TITLE:
Replace MMS with IMS

REF NO: TJ 31847.1.0	ISSUING DEPARTMENT: Technical Service	CAR MARKET: United States and Canada	
PARTNER: 3 US 7510 Volvo Car USA		ISSUE DATE: 2016-11-03	STATUS DATE: 2016-11-07
FUNC GROUP: 3662	FUNC DESC: Burglar alarm equipment	Page 1 of 5

TJ Instruction T9388

Title	Intrusion sensor	Page:	1 (3)
Action	Modification	Operation number:	98638-2

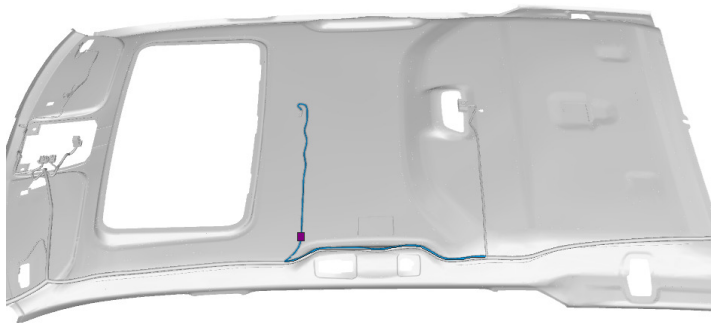
The front MMS (MMS2) is no longer available as spare part. The vehicle can be adapted to use an IMS instead.

1.

Remove headlining refer to:

Route the cable to rear sensor and connect the adapter cable

Attached the cable with melting adhesive

Note! Use a new headlining
